Access Compliance Report

Public Rights-of-Way

(Pedestrian Signals)

Intersection ID: N/A	Main Street:	Cross Street: N/A	Location: N/A
ADA ID: 9EA2AAE5F7F7	Signal Type: One Push Button-APS	Overall Compliance: No	Severity Score: BTN 1: N/A BTN 2: N/A No BTN: N/A
Codes/Mitigation Info/Possible Solution		Field Measurements/Component Compliance

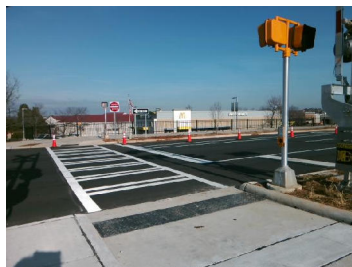
PROW/ADA: TMUTCD 4e.08, R404.7.3, R404.7.2, R209.1, MUTCD 4e.10

N/A	B 1 FWD Approach Width (in)	N/A	N/A	B 2 FWD Approach Width (in)	N/A
N/A	B 1 FWD Approach Obstruction?	Yes	N/A	B 2 FWD Approach Obstruction?	N/A
N/A	B 1 FWD Approach Obstruction Dist (in)	4.0	N/A	B 2 FWD Approach ObstructionDist (in)	N/A
N/A	B 1 PARA Approach?	Yes	N/A	B 2 PARA Approach?	N/A
N/A	B 1 PARA Approach Constrained?	Yes	N/A	B 2 PARA Approach Constrained?	N/A
No	B 1 PARA Approach Reach (in)	16.0	N/A	B 2 PARA Approach Reach (in)	N/A
No	B 1 PARA Approach Width (in)	48.0	N/A	B 2 PARA Approach Width (in)	N/A
N/A	B 1 PARA Approach Obstruction?	Yes	N/A	B 2 PARA Approach Obstruction?	N/A
N/A	B 1 PARA Approach Obstruction Dist (in)	4.0	N/A	B 2 PARA Approach ObstructionDist (in)	N/A
Yes	B 1 Clear Floor Space Slope (%)	0.1	N/A	B 2 Clear Floor Space Slope (%)	N/A
Yes	B 1 Clear Floor Space XSlope (%)	1.3	N/A	B 2 Clear Floor Space XSlope (%)	N/A
N/A	B 1 PAR Slope (%)	N/A	N/A	B 2 PAR Slope (%)	N/A
Yes	B 1 Height (in)	39.0	N/A	B 2 Height (in)	N/A

N/A	B 1 Clear Xing Direction?	Yes	N/A	B 2 Clear Xing Direction?	N/A
	B 1 Crossing Direction	To NW		B 2 Crossing Direction	N/A
Yes	B 1 DistanceTo XWalk (in)	8.0	N/A	B 2 DistanceTo XWalk (in)	N/A
No	B 1 DistanceTo Curb (in)	8.0	N/A	B 2 DistanceTo Curb (in)	N/A
Yes	B 1 Diameter (in)	2.0	N/A	B 2 Diameter (in)	N/A

Possible Solutions: Replace Signal Push Button With APS Button on New Post. Remove & Relocate Sign.
